ARBORICULTURAL STATEMENT ADDENDUM
For
Proposed construction of a block of four
apartments, with means of access and parking
within the grounds of Clayton Manor

Planning References
3/2023/0930
2/2010/0414
3/2013/0759

Report Ref:
DTCL.298.AMS.(2).2024

Addendum Date:
29 February 2024

Fig 1

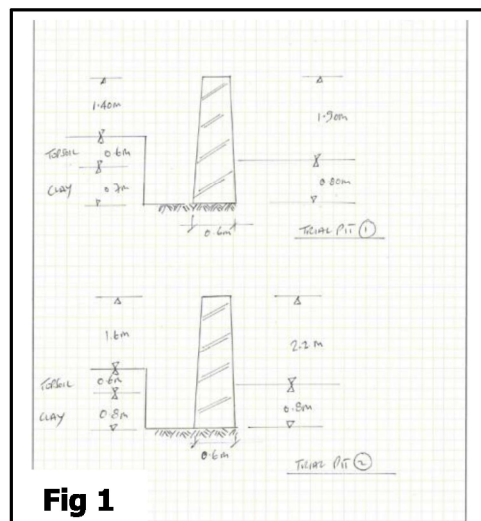
You have now agreed that there will be excavation works within the potential RPAs of the protected trees so it would be beneficial to dig some Trial Pits (either by, or supervised by a qualified Arborist approx. 0.6m - 1.2m where applicable) throughout the potential RPA's to ascertain if indeed any roots are present, especially over 2.5mm. Please note that the lawned area is raised so Trial Pits might have to be dug slightly deeper.

1. That there is no/insufficient evidence to prove that there are "very little if any tree roots" within the development site.
2. Not enough evidence to show that the proposed development would not have a negative impact on the trees' amenity value or potentially destabilise the root plate.
3. The two trees have asymmetrical crowns which overhang the proposed parking spaces, and this suggests that the root plates extend into the development site.
4. Pruning back the overhanging branches would be "***in direct contravention of BS 3998: 2010***".
5. An AIA Report is required to deal with mitigation and irrespective of any evidence provided by trial pit excavation, the amenity value of the trees, and their root plates' stability would be negatively impacted.

- 3.1.1 The basis for the assertion that there are few or any roots under the development site was based on the fact that the boundary wall is 1.4m in height with deep foundations and it is approximately 160 years old, showing no signs of damage, deterioration, or distortion. The two trees on the other side of the boundary wall, post-date the wall by a considerable period of time, an estimate is over 75-years.
- 3.1.2 In order to see if any tree roots are present two trial pits (TP1 & TP2) were opened on the development site side of the wall at positions directly opposite the trunks of the remaining two trees, (Drawing No. 1210/SK/04 Annotated). TP1 was opened to a depth of 1300 mm, and TP2 to a depth of 1400 mm, (Photograph 1). The foundations of the wall were found to be 800 mm deep in both trial pits, (Figure 1).

Figure 1: A schematic representation of the trial pits showing the depth of the excavations and foundations.

3.1.3 No roots were found coming through or under the wall into the development site, (Photograph 2). The only root material observed in the trial pits is from shrubs that are/were growing on the development site side of the wall.

3.1.4 The excavations clearly show that there are no tree roots on the development site side. Therefore, the Trees & Countryside concern about this aspect has been shown to be unfounded following the suggested excavations.

Drawing No. 2101/SK/04 Annotated

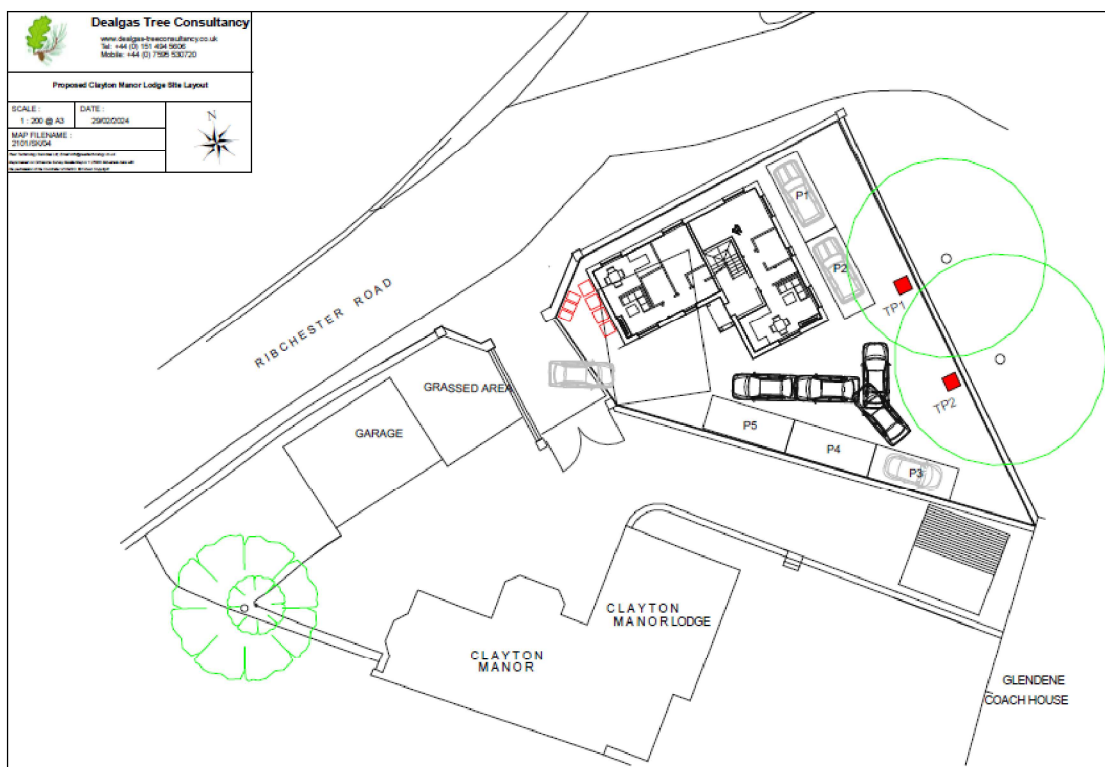
However, as mentioned in my original email, over 60% of two of the tree's crowns overhang the proposed parking bays 1, 2, & 3, so there will always be overhanging branches unless the trees are felled or severely pruned which would be in direct contravention of BS:3998 2010 Tree Work Recommendations. Taking this into consideration I do not think the proposed carparking design is appropriate for the safe retention of the protected trees and their amenity value.

3.4.2 The claim that over 60% of the crowns overhang the proposed parking areas is an exaggeration. It is true that there is some overhang, but not as much as 60% or more, as is claimed in the Trees & Countryside response. The lower overhanging branches, i.e., up to 7 m above ground would be pruned to reduce the extent of the overhang, and this would not adversely affect the amenity value of the trees.

4.1 The AMS of February 2024 specified a 'no dig' and cellular confinement system for the construction of the proposed parking areas. At that time, February 2024, it was not known if any of the roots of the protected trees were growing under the proposed parking areas. However, the trial pit excavations have shown conclusively that there are no roots of the protected trees in the development site. Therefore, the no dig/cellular confinement system **is not required**.

- 5.3 Branches of the off-site trees overhang two of the proposed parking areas to some extent, but these can be pruned back to reduce the crowns and remove the overhang.

- 5.4 Only overhanging branches up to 7 m above ground level would be pruned and all work would be in accordance with BS3998: 2010 or any future iterations of that standard. This can be made a condition of planning permission.

- 5.5 The no dig/cellular confinement system for the construction of the car parking areas and other hard surfaces to protect tree roots, as set out in the AMS of February 2003 will not be required.
